VICTORIA CROSS OVER STATION DEVELOPMENT

SUBMISSIONS REPORT

SEPTEMBER 2018

Figure i — Exhibited building envelope

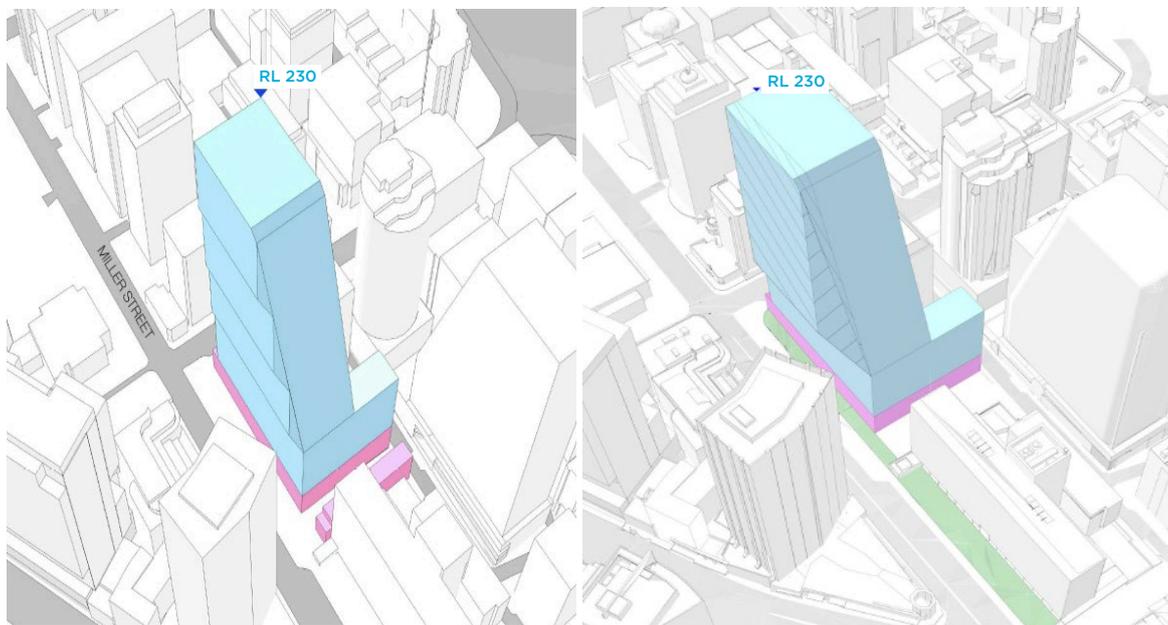
Sydney Metro has modified the concept proposal to simplify the design of the building envelope that projects over the Miller Street setback. This modification is in response to a request from DPE to reconsider the building envelope form and to address a number of issues raised in submissions, including the impact of the stepped building envelope on the Miller Street streetscape and the impact on views to neighbouring heritage buildings.

This amendment to the building envelope means greater flexibility for the design expression of the future building. The amendment has been considered by Sydney Metro’s Design Review Panel (DRP). It was supported subject to the future building demonstrating design excellence, and satisfying a number of specific design and environmental considerations. These requirements have been incorporated into an updated version of the Victoria Cross Design Guidelines (Appendix C) and are discussed in Chapter 7 (Amended project) of this Submissions Report.

To support this amendment to the building envelope, an update Clause 4.6 Variation Request has been prepared (Appendix Q) seeking a variation to the Miller Street setback provisions in Clause 6.4 of North Sydney Local Environmental Plan 2013 (NSLEP 2013).

Figure 1.6 – Amended building envelope

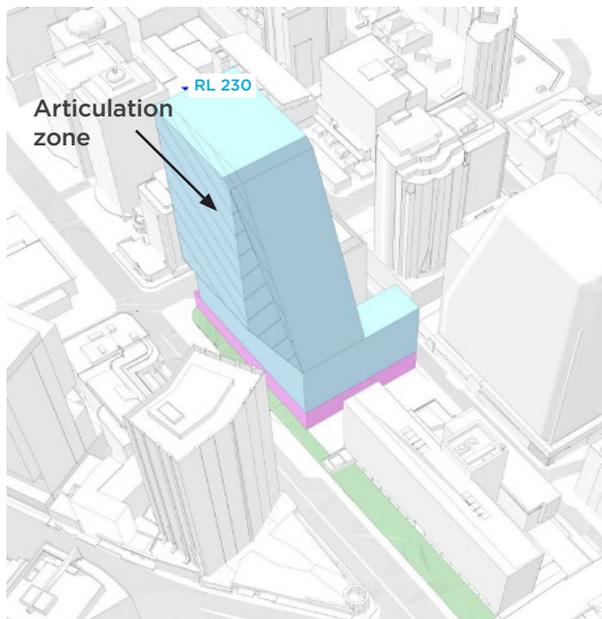
DPE has requested further design rationale and justification for the building envelope form, and has questioned the appropriateness of the building envelope closely reflecting the architectural form of the indicative OSD design (refer to Figures 1.3 and 1.4 above) in respect to elements of the building envelope that project over the Miller Street setback area.

The articulation zone defines the area of the building envelope within which the future building can occupy and which would project over the Miller Street setback area. Figures 1.5 and 1.6 below illustrate the exhibited building envelope and amended building envelope, respectively, with the hatched area in Figure 1.6 illustrating the extent of the new articulation zone.

The amendment to the building envelope has been considered by Sydney Metro’s Design Review Panel (DRP) and is supported subject to a number of design and environmental considerations relevant to the future detailed design of the OSD, as detailed in Section 3.4 of this Response to Submissions Report (Submissions Report).

Figure 5.2 – Victoria Cross building alignment (Miller Street)

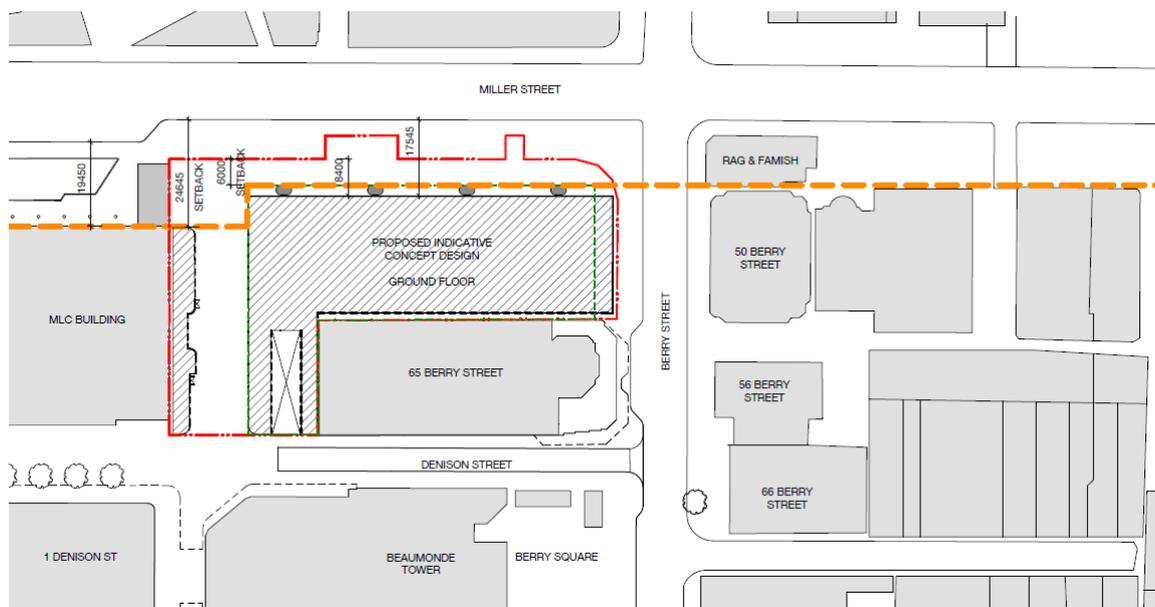
Sydney Metro notes the comments from Council. The comments raised above are contrary to Council's endorsed and published vision of the Victoria Cross site. Sydney Metro has developed the concept proposal for the Victoria Cross OSD to align with NSLEP 2013, and the planning policies and controls which apply to this development site, as detailed in Chapter 6 (Assessment of compliance with strategic plans) and Chapter 7 (Assessment of compliance with statutory provisions) of the EIS. This includes the Sydney Metro Planning Study (supported by the North Sydney Capacity and Land Use Study) and the amendments to NSLEP 2013, as reflected in the North Sydney Centre Planning Proposal, both of which have recently been endorsed and/or adopted by Council and reflect Council's vision (at that time) for a significant commercial development above Victoria Cross Station.

Further, it is noted that the building alignment at ground level is consistent with the varied setbacks identified in the Sydney Metro Planning Study for a development option incorporating a northern tower and is consistent with the setback provisions in NSLEP 2013. This matter is discussed in Chapter 8.1 (Built form and setbacks) of the EIS and the building alignment is illustrated in Figure 5.2.

Figure 5.3 – Indicative station design – public domain and open space

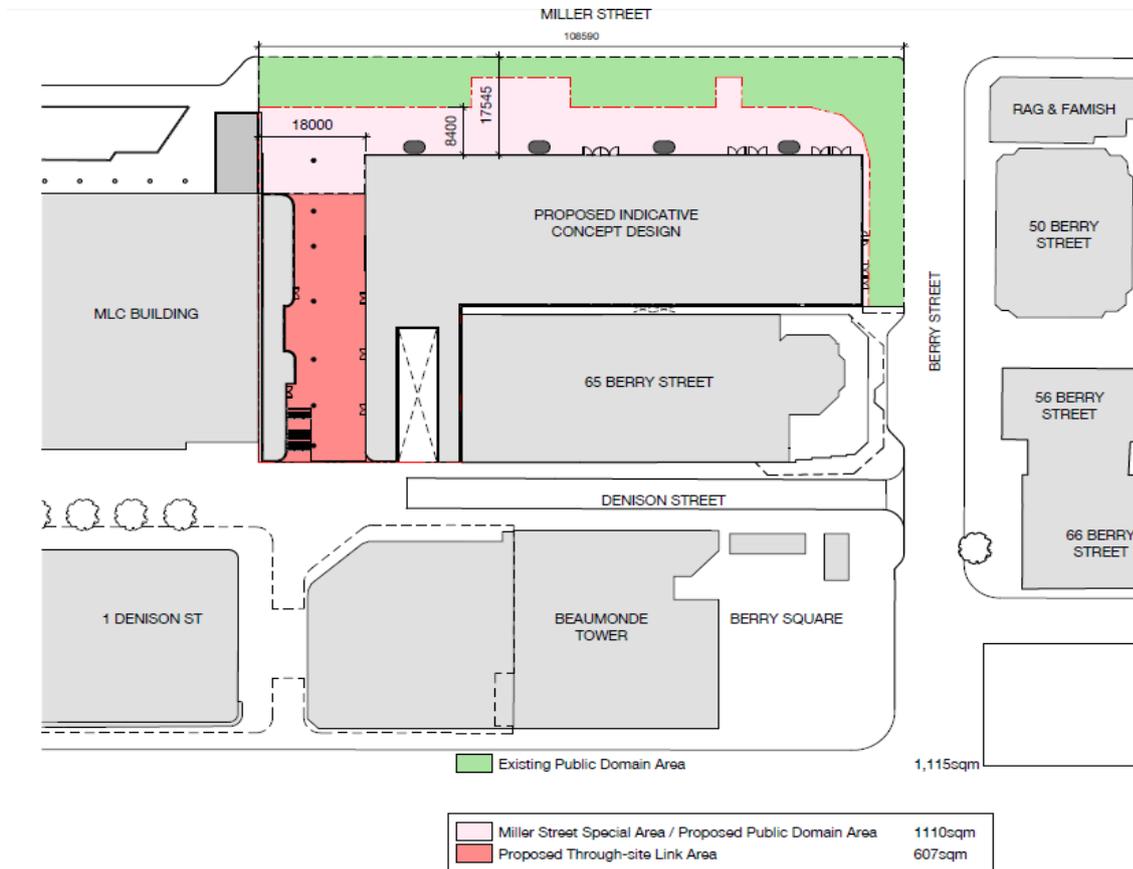
In response to concerns raised by Council in relation to the public space offering, Sydney Metro has completed an analysis of the current concept design for the integrated station development. This analysis has compared the quantum of public domain and public accessible areas on the site pre-demolition with the current concept design. With reference to Figure 5.3 below, it has been determined that the current integrated station design provides a significant contribution to the public domain of North Sydney CBD including the following:

- The consolidation of the civic space on the Miller Street frontage where it can integrate with the linear space in front of the MLC building, as far as practicable (noting the constraint of the MLC café, as acknowledged by Council in its submission).

- An accessible through site link between Miller Street and Denison Street, which, as detailed in Section 3.4.5 of the EIS, would connect with existing and planned links further to the east including the new development at 1 Denison Street and further east to Walker Street forming a continuous east-west link between Walker and Miller Streets.

Figure 7.4 – Axonometric view – amended building envelope incorporating the articulation zone

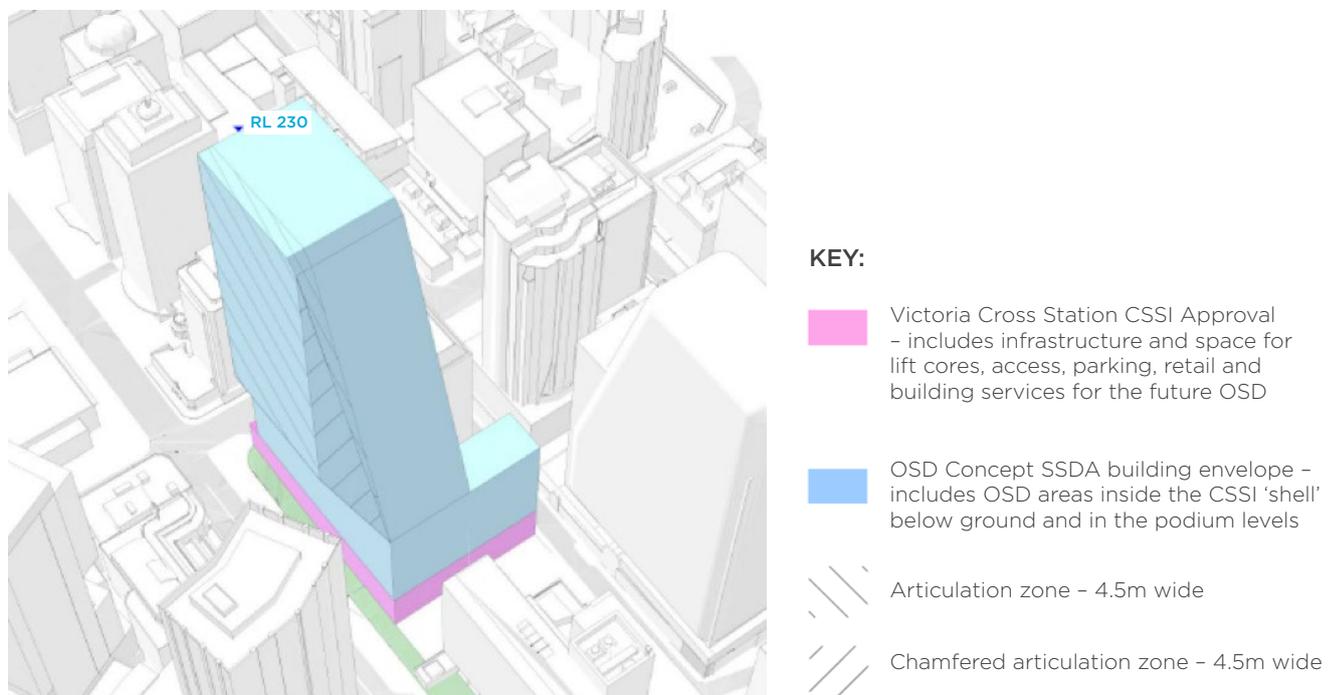
DPE has requested further consideration be given to the appropriateness and extent to which the stepped projection of the building envelope over the Miller Street setback closely reflects the architecture of the indicative OSD design (i.e. the stepped architectural form, as illustrated in figures 7.2 and 7.3 below). Further investigations have been undertaken in relation to this element of the exhibited building envelope (refer to Appendix E and Appendix P). This includes consultation with Sydney Metro DRP to consider options for simplifying and providing greater design flexibility for the future building form. This has included consideration of the extent of the projection, its impact on the streetscape and views to neighbouring building items (including heritage items), and overshadowing impacts to the public domain. Further, consideration has been given to the building envelope alignment in the context of Miller Street. These matters are discussed in detail in Section 8.1 of this Submissions Report.

As a result of the above investigations, Sydney Metro has amended the building envelope form to provide greater design flexibility. The amended building envelope form, as illustrated in Figure 7.4, retains the 4.5-metre maximum projection over the Miller Street setback area but replaces the stepped form with a flat, continuous edge. The southern end of the projection is tapered to prevent any additional overshadowing of the Miller Street Special Area. The extent of the building envelope which projects over the Miller Street setback is now referred to as an ‘articulation zone’ (refer to Appendix P).
